Board Agenda Item #:	IV A – Action Item
Date:	February 13, 2020
To:	Magnolia Educational & Research Foundation dba Magnolia Public Schools (“ <b>MPS</b> ”) Board of Directors (the “ <b>Board</b> ”)
From:	Alfredo Rubalcava, CEO & Superintendent
Staff Lead:	Patrick Ontiveros, General Counsel & Director of Facilities
RE:	Recommendation of Ad Hoc Committee to Board to Approve MSA-1 Change Order Requests

The Ad Hoc Committee recommends and moves that the MPS Board approve change order requests 37 to 54 up to \$176,614.96 as presented by Oltmans Construction Co. (“**Oltmans**”) for the new construction project for the benefit of MSA-1 at 18220 Sherman Way (the “**Project**”) with the payment amount to be confirmed by MPS Staff based on a review of all change order requests and back-up.

Oltmans Change Order Requests

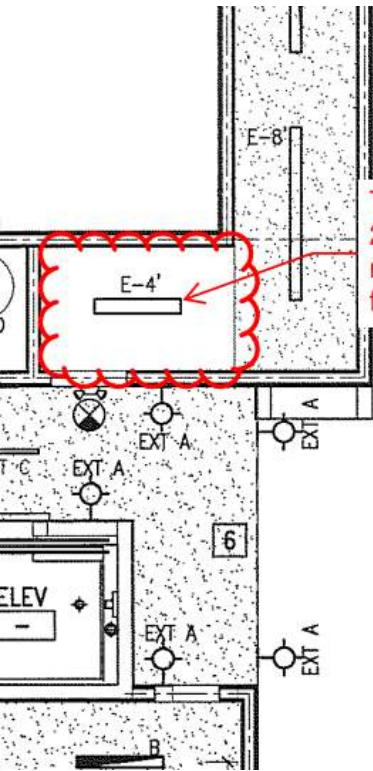
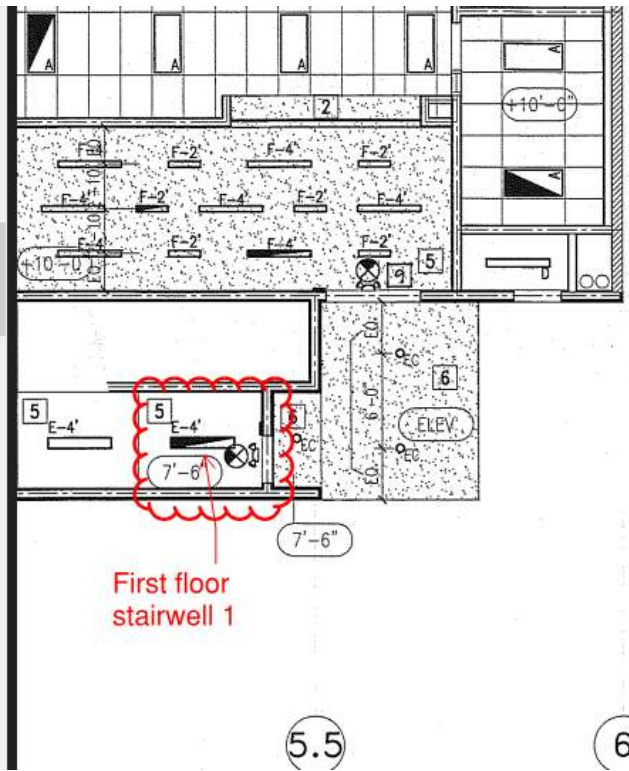
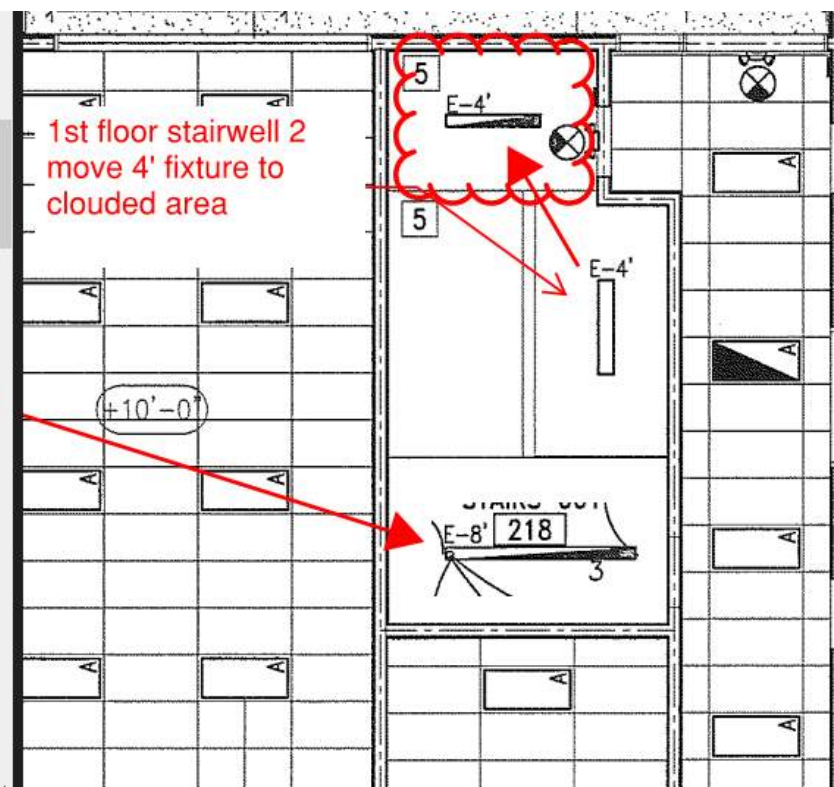
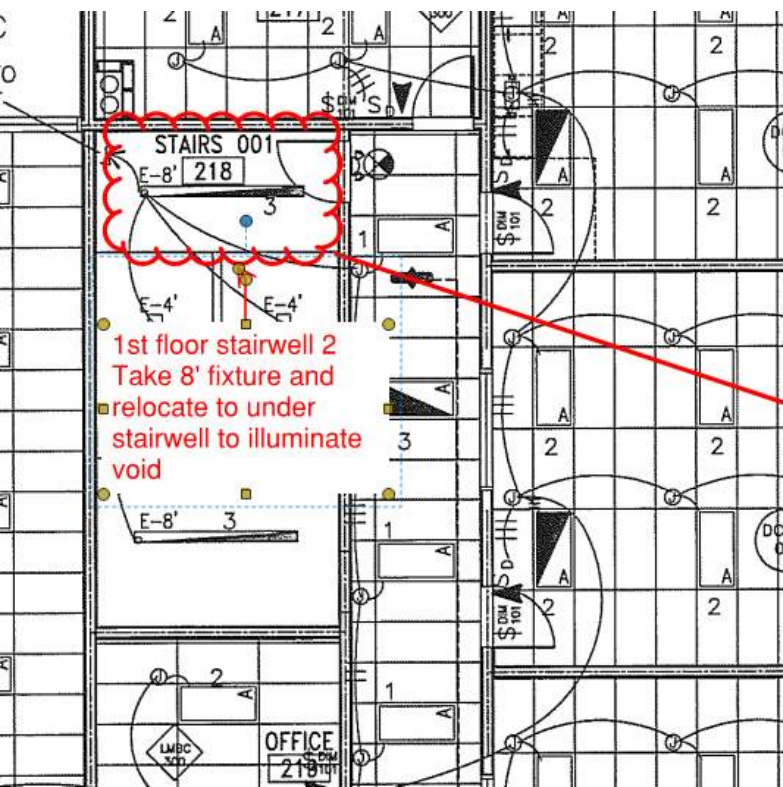
Please provide mounting clarification for the E4 fixtures in the stairwells (sheets E3.1 & E3.2). The prints show the fixtures to be mounted on the underside of the steel stairs. Attached is a photo showing the field conditions that are typical for both stairwells. In the photo you can see the all Steel Stairs are surrounded by Beams and Gluelams.

2nd floor stairwell 2.  
due to field conditions  
we are swapping the  
location of these 2  
fixtures with each  
other

This 3rd floor stairwell  
2 - 4' fixture will  
relocate to the 1st  
floor stairwell 1

RFI #154  
Reference: 6/S7.1

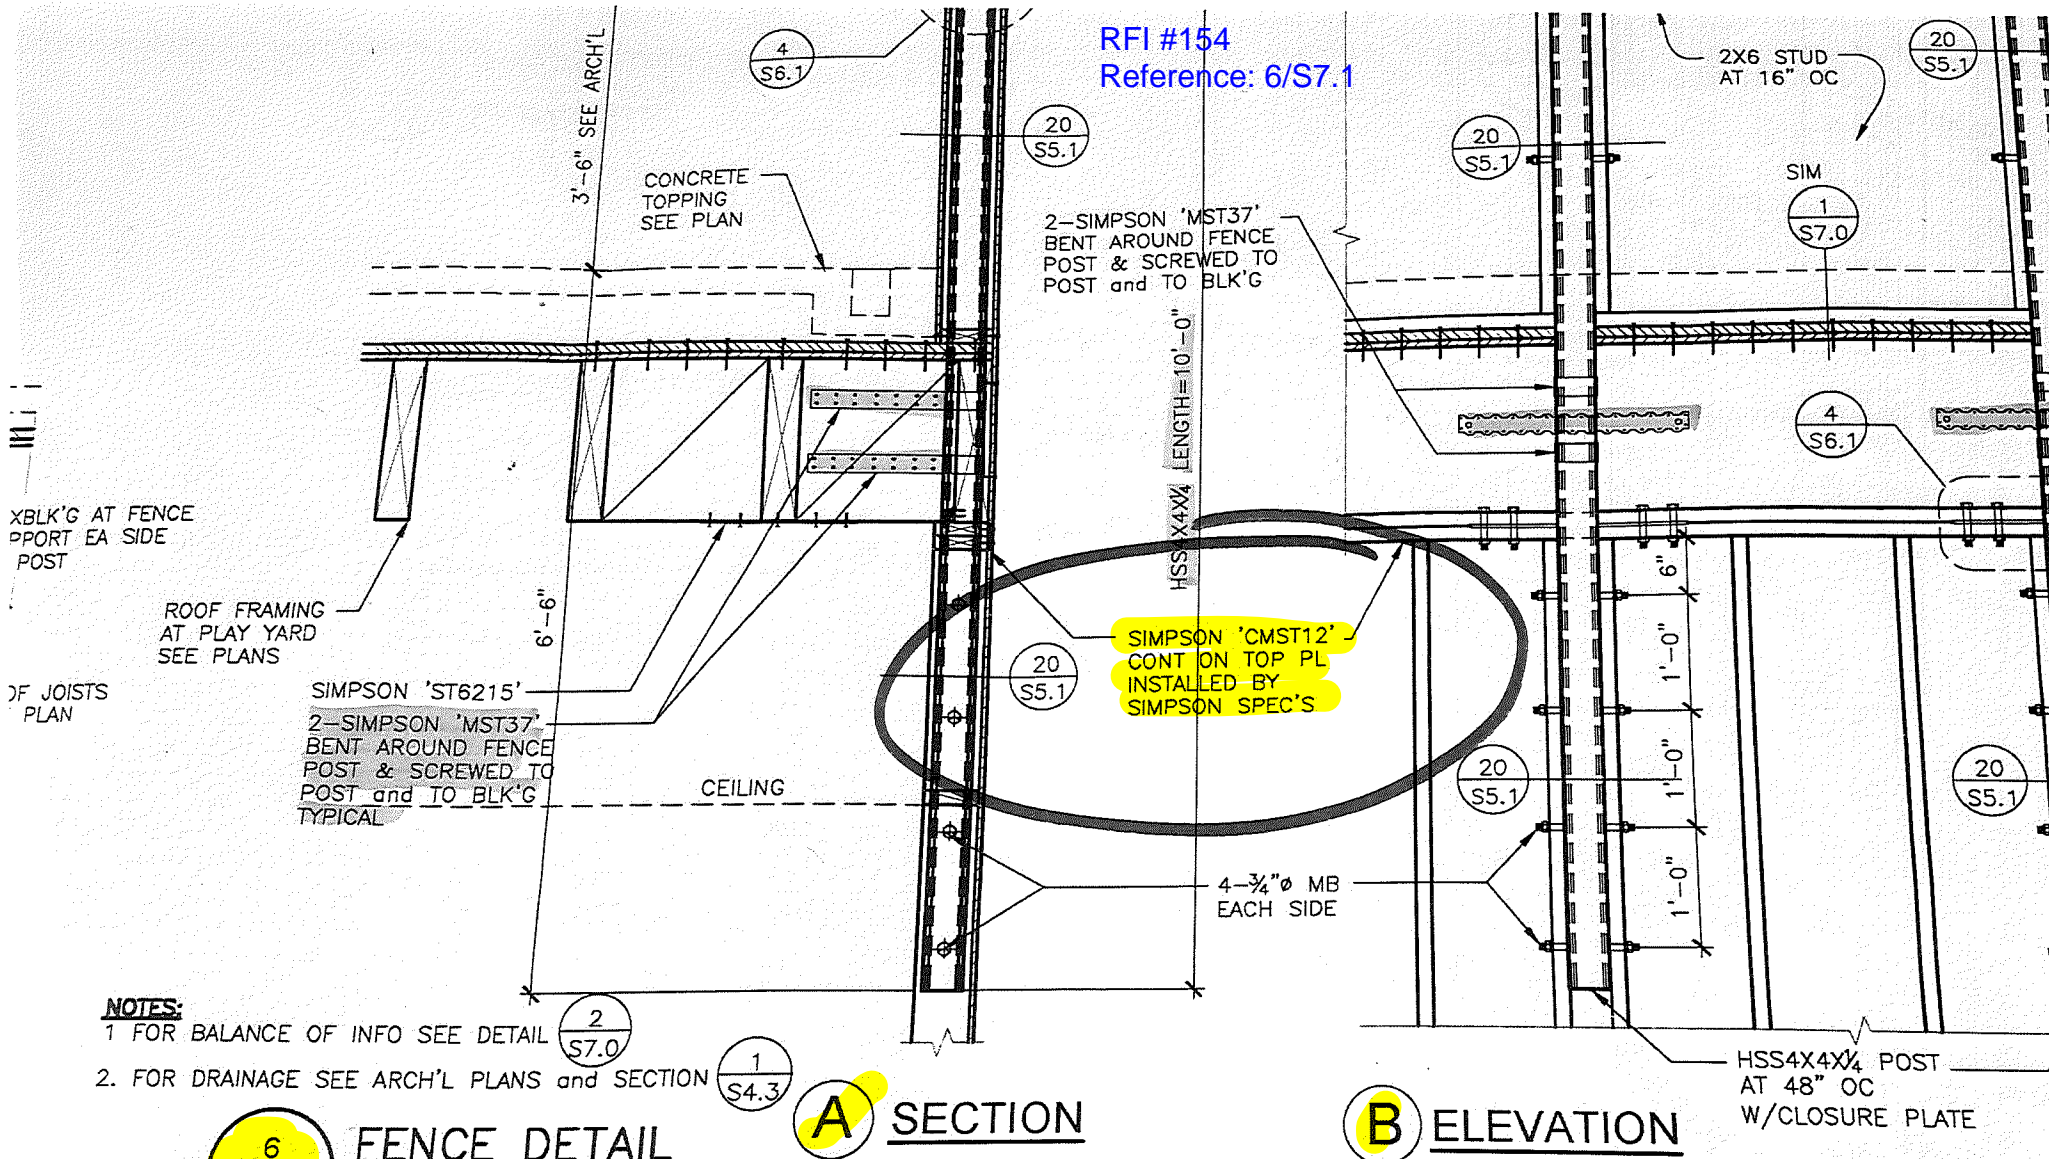
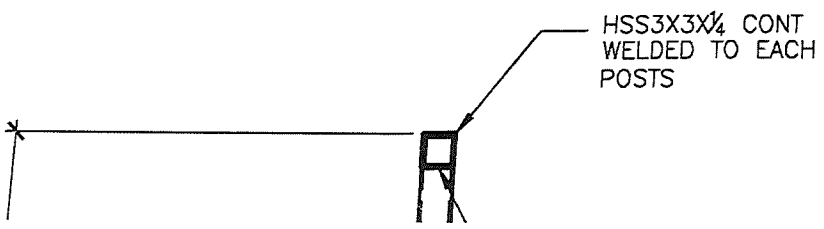
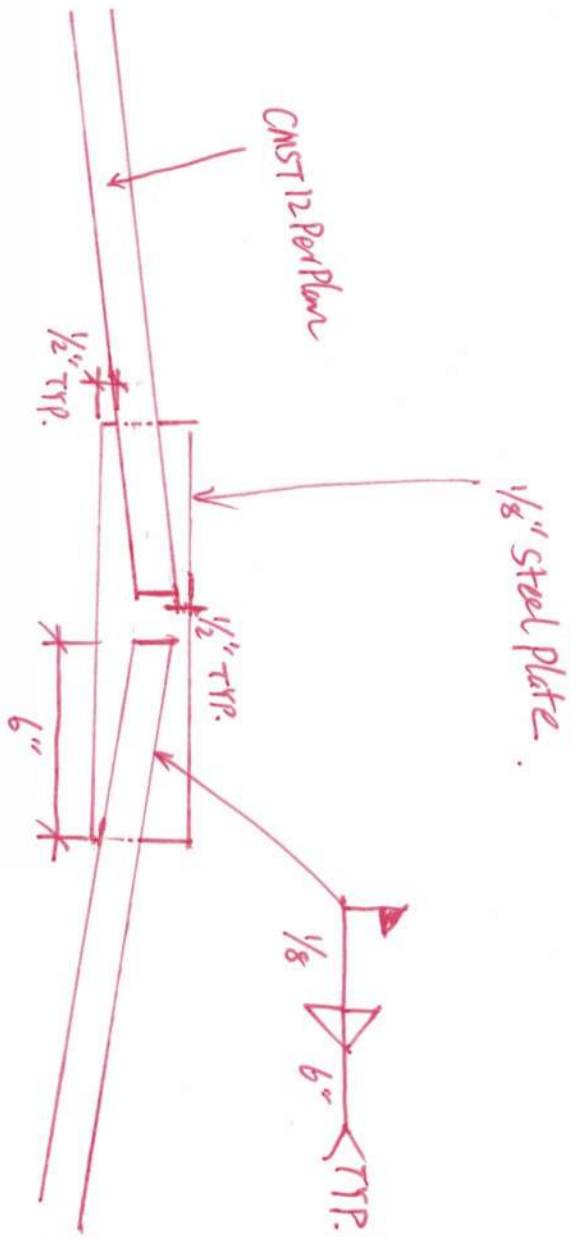
Sheet S 7.1 detail 6 calls out for a CSMT 12 strap, see attachment, this strap cannot be installed on the side of the top plate due to the required roof pitch. The strap cannot be bent to match the pitch. Please advise.

Splice at the strap turning point with 1/8" steel plate with 1/8" x 6" long welding at top and bottom of each strap end.  
Please see the attached sketch.
